TCI RL & IL Proposal

G. ZIMMERMAN / CME CONSULTING (ADI, APL GROUP, CISCO, INFINEON,
ONSEMI, SONY)

10/15/2025

The new comment seeks to resolve the author's unsatisfied comment i-38 on D3.0, and the issue goes comment 115 on D2.2 in working group ballot (Stephan Schreiner)

Clause 189 TCI Return Loss

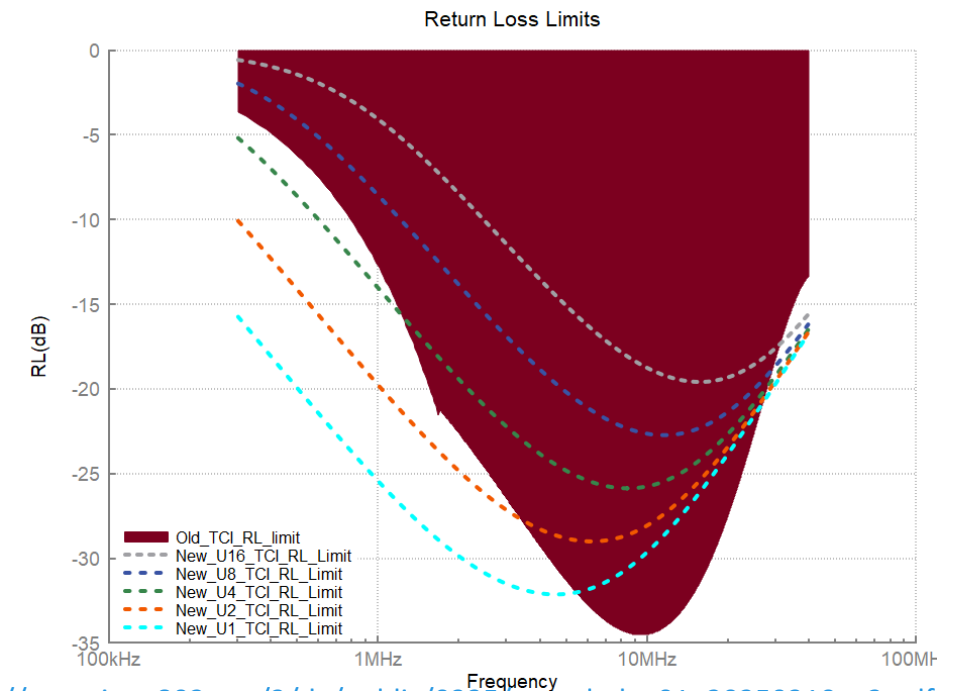
Provides RL dependent on unit loading for clause 189 MPis that are also TCIs

Has fairly little margin to small inductor implementations in the critical 7 to 12 MHz region

Based largely on lumped element components (e.g., inductors) used for “in-and-out” topologies

Schreiner Sept 2025 Proposal

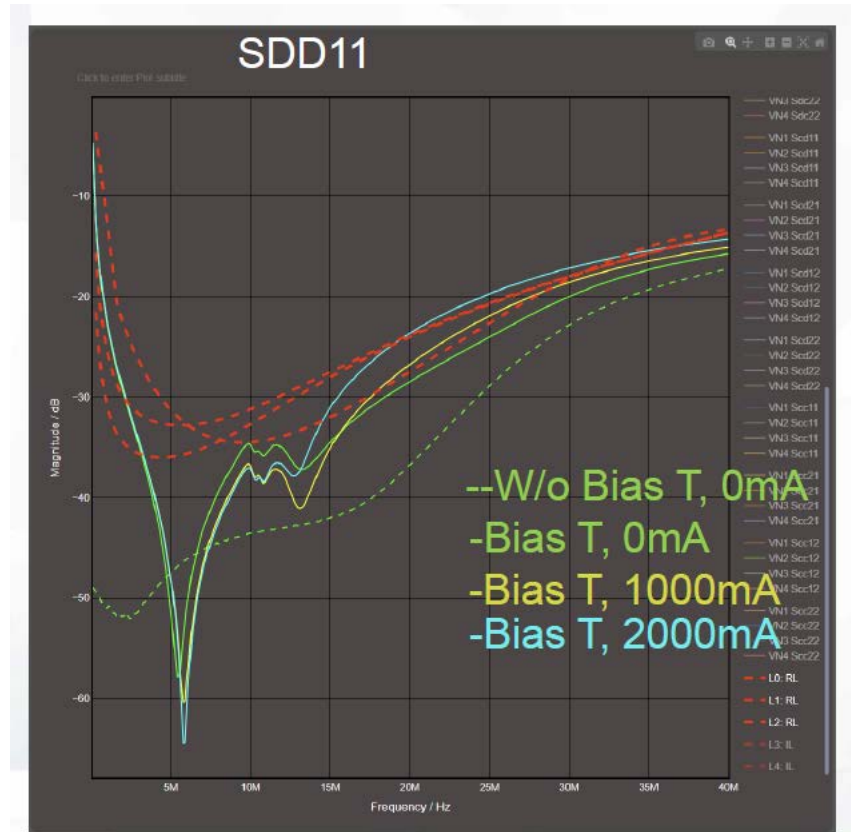
https://www.ieee802.org/3/da/public/0925/schreiner_3da_01_september_2025.pdf compares to measured results with ferrite “inline + drop” TCI implementations to Clause 189 specification

- Requires higher slope on return loss at frequencies > 10 MHz
- Also points out insertion loss of TCI needs to be adjusted

Proposed equation validates to provide slightly better performance than existing equation 189-1, due to more stringent RL in the critical 5-12 MHz region

Problem: Inconsistency

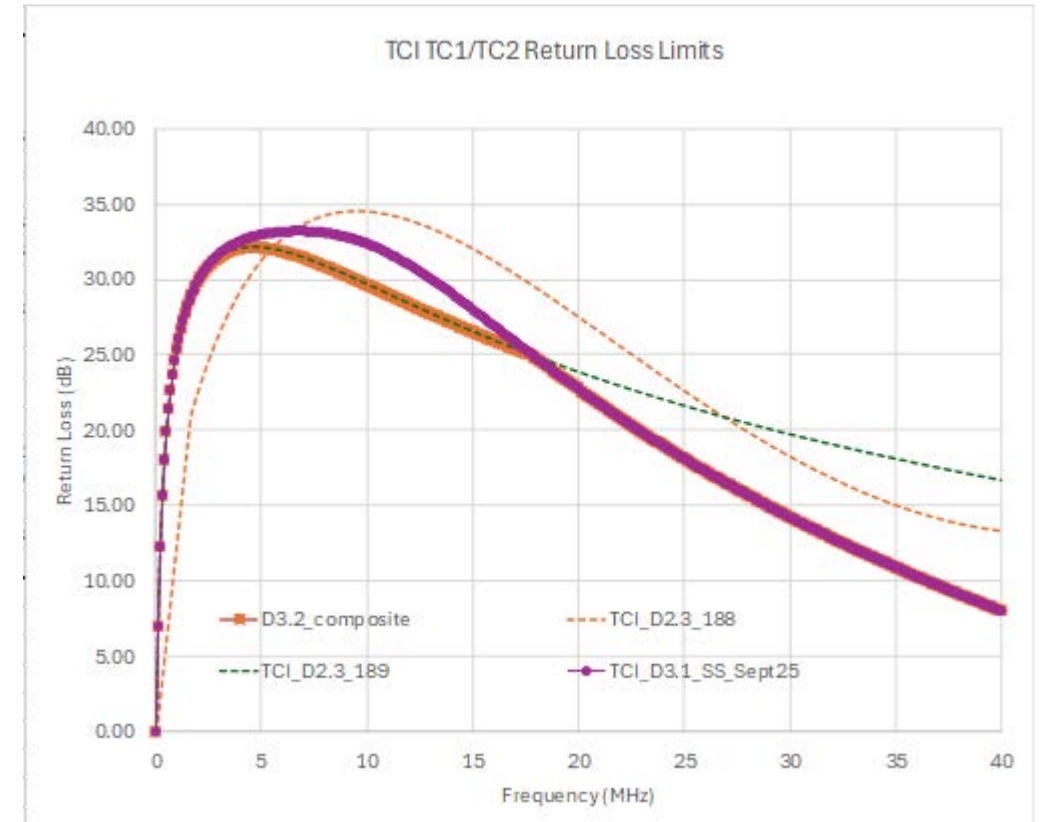
Paul “in-and-out” models for small inductors & component variation don’t work with Schreiner “in-line + drop” models, AND

Schreiner models don’t work with Paul’s more stringent return loss at higher frequencies

Neither model alone fits both implementation styles

- Form “Composite” RL from existing 189-1 return loss below 18 MHz, and Schreiner RL above 18 MHz

TCI Insertion Loss

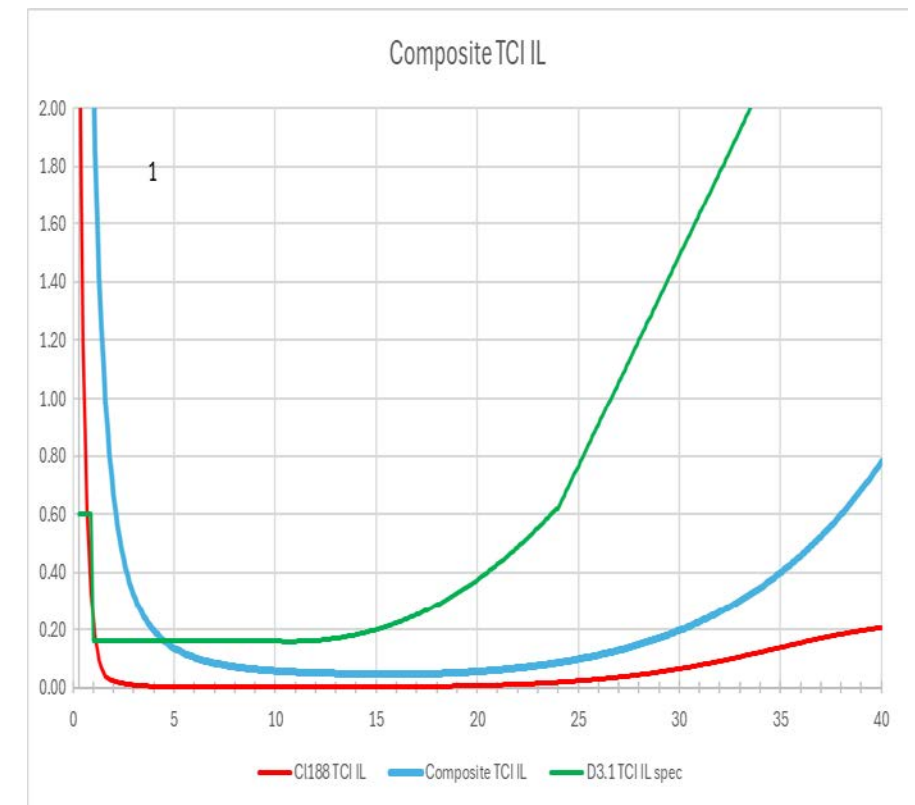
As Schreiner points out, the TCI IL is inconsistent with the RL

- Reflected energy doesn't go through the TCI...
- The issue here is at low frequencies
- It also doesn't matter for performance...

Frankly, we didn't need to specify insertion loss all the way to 0.3 MHz for a DME system, but we are stuck with it from 802.3cg

188.9.1.1 TCI insertion loss: change low frequency range of Equation 188-6) from 0.6 dB to be: $3 - (f-0.3)*2.84$ dB $0.3 < f < 1.3$

When the MPI is also a TCI, the TCI insertion loss from TC1 to TC2 shall meet the values of equation 189-2 at frequencies below 5 MHz. At frequencies above 5 MHz, the TCI insertion loss specified by equation 188-6 shall apply.
